## MEMORANDUM

**SUBJECT:** Heritage Permit Application  
216 Main Street Unionville  
Varley Art Gallery Courtyard Pavers Renewal

**Project:** Courtyard/Accessible Parking Pad Paver Renewal Project- Fall 2024  
Frederick Varley Art Gallery

## Appendix 'B'

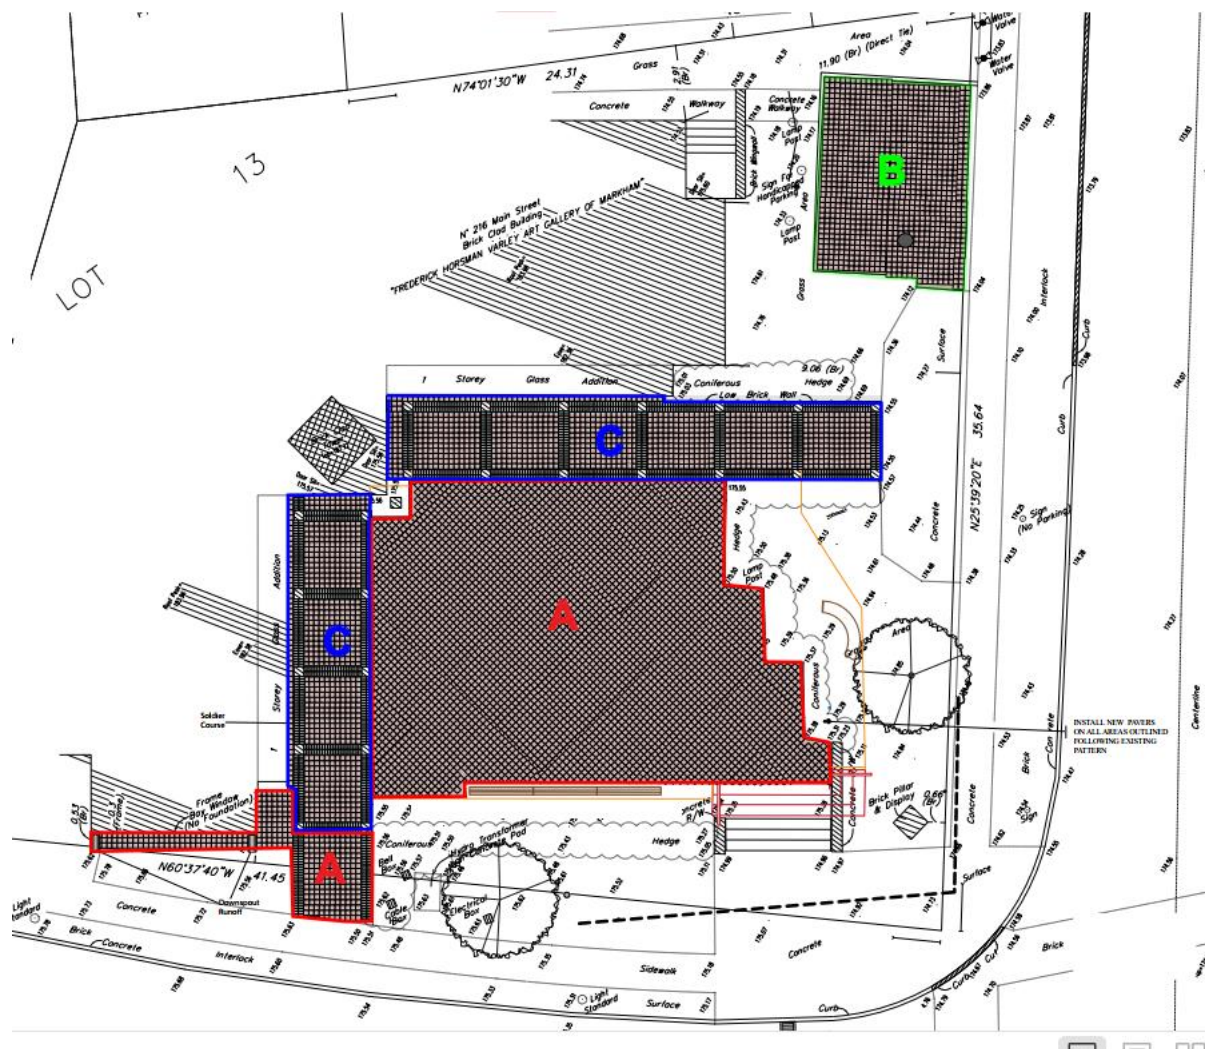
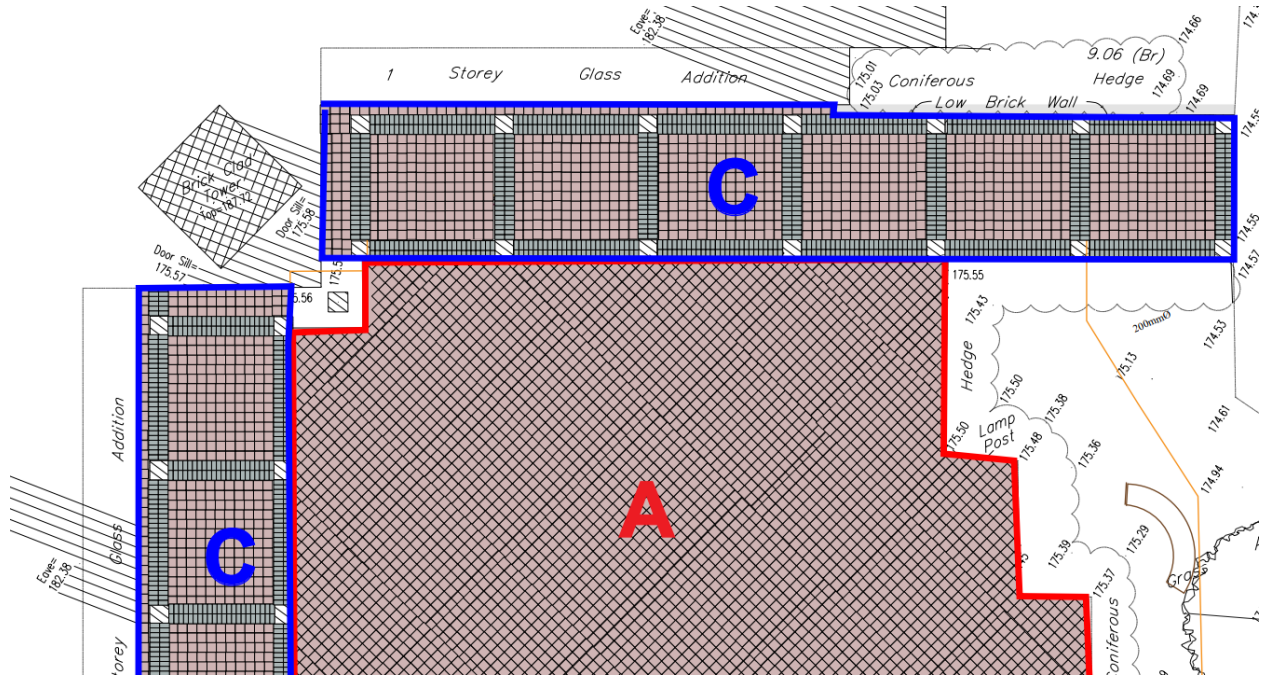
- The pavers are to be introduced in the Varley courtyard (A) and adjacent areas (B and C) (see Attachment 'B').
  - The plan is to focus on the most exposed and deteriorated sections. This means that along with the Gallery's main courtyard and small adjacent areas (A), the accessibility parking spot (B) will also be addressed as it is in very poor condition. The accessibility parking is outside the scope of the Streetscape project, and it will look unappealing if not addressed.

- Area C, is under the arcades. Because much more protected it is in comparatively good condition, requiring minor repairs.
- The plan is to replace the existing pavers, with similar, precast concrete pavers, (8 x 8 x 2 3/4 inches or 200 x 200 x 70 mm, see below), and following the existing pattern.

- Heritage Staff opine that using the Streetscape Project Sidewalk/ Boulevard paver treatment on the Gallery property would help better integrate and connect the art gallery to the Main Street as the northern anchor of the new streetscape project. However, from a heritage impact perspective, staff has no objection to the use of the square grey paver proposed by the Gallery as it appears it will generally complement the Molina Paver in Moraine and Luna colours that will be used for the adjacent sidewalk and boulevard.
- It is suggested that the Gallery explore using the Molina Paver (Moraine and Luna, random pattern) in the accessible parking area (Area B) if timing and costs permit, as it will be immediately adjacent to the new sidewalk/boulevard treatment and would appear to enhance the connectivity of these spaces.

That Heritage Markham has no objection from a heritage perspective to the proposed paver renewal project at the Varley Art Gallery (216 Main Street, Unionville).

Appendix 'C' - Approved Work on Main Street Adjacent to Gallery and Material Selection

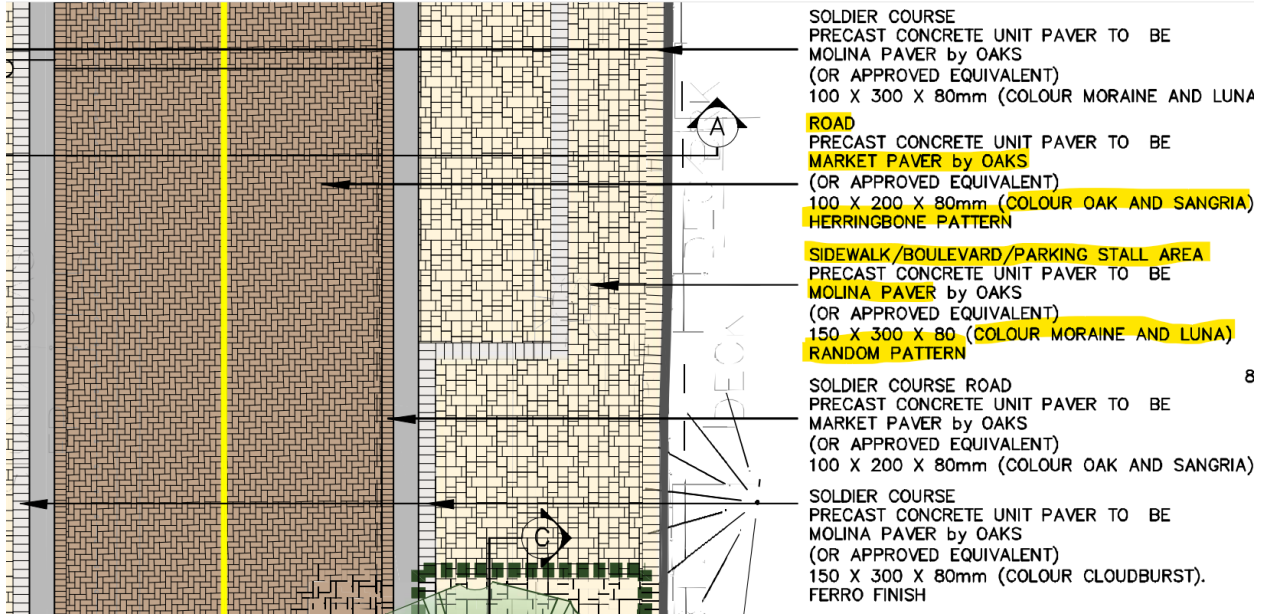
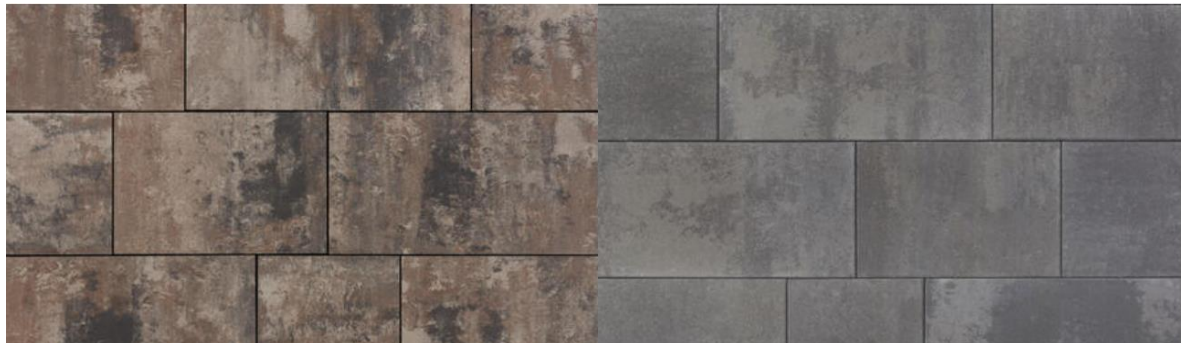
- Heritage Section staff asked if consideration was given to using the same pavers selected for the Main Street sidewalk/boulevard treatment to achieve a more integrated approach to the overall design of this area.

- To replicate the boulevard pavers would require the use of a precast concrete paver, Molina by Oaks or approved equivalent, in a random pattern. The selected colour is Luna and Moraine. The specs indicate that the pavers have to be laid on new material: 25 mm bedding sand on 175mm concrete Base and 200 mm of granular “A” base. This likely means longer removal, disposal and replacement of substrate materials and likely increased cost.
